ERRATA CORRIGE

We inform you that at page 132 of the Product Catalogue 2022 the dimensions of P/N 1608380, 1608381, 1608384 and 1608510 and the wire section of P/N 1704000 are wrong.

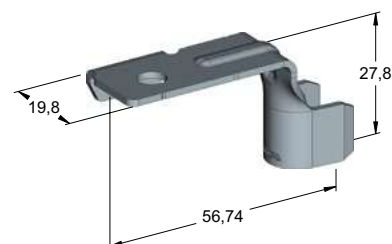
Please find the correct information highlighted here below.

IMG	DESCRIPTION	L mm	L1 mm	L2 mm	SCREW	WIRE SECTION mm ²	MATERIAL	MATERIAL THICKNESS mm	P/N BOX	MOQ
1	FDU G90	23	16,7	17	M8	25÷40	CuZn-Sn	1,5	1608380	1500
	FDU G90	23	16,7	17	M6	25÷40	CuZn-Sn	1,5	1608381	700
	FDU G90	27,4	12,6	17	M6	25÷35	Cu-Sn	1,5	1608384	600
	G90	23	16	16	M8	40, 50, 70	Cu-Sn	1,8	1607500	600
	G90	24	16	16	M8	30 + 30	Cu-Sn	1,8	1617500	600
2	FDU G90				M6	25÷40	CuZn-Sn	1,5	1608382	700
3	PTC G90	17,6	15,4	14	M8	2,5÷4	Cu-Sn	0,8	1608500	1700
	STR-S G90	17,3	11,4	12,7	M6	2,5÷4	Cu-Sn	0,8	1608510	2300
4	FDU GM90M6P				M6	25÷35	CuZn-Sn	1,5	1704010	600
5	SX FL90 P				M6	25 - 35	CuZn-Sn	1,8	1704000	500
6	NEGATIVE BATTERY RING TERMINAL				M6	35 - 50	Cu-Sn	1,5	1600047	500
